8th Edition (2023) Florida Building Code

Proposed Code Modifications

TAC: Roofing

R9343/G3-18

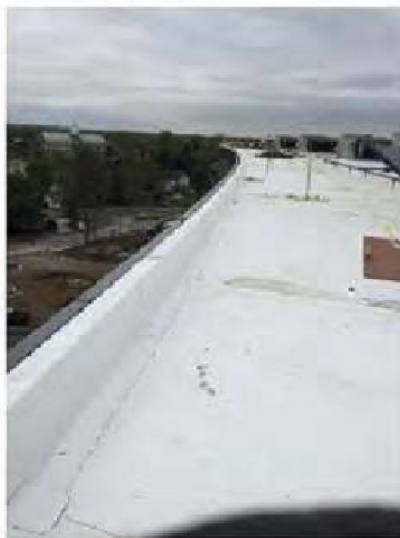
This revision will provide additional options for maintaining a continuous air barrier. For example, the roof membrane could be used to wrap the top of the parapet wall and extend down the exterior side of the wall. The membrane could then be tied into the wall air barrier system. See also Figures 1 through 4.

Fascia on 6" wide by 4" high "Parapet"

Note 4" high
x 6" wide
"parapet"

Adelman Travel - Fascia on radius "parapet" @
6" high x 6" wide

Hyvee Iowa Fascia on 18" parapet condition
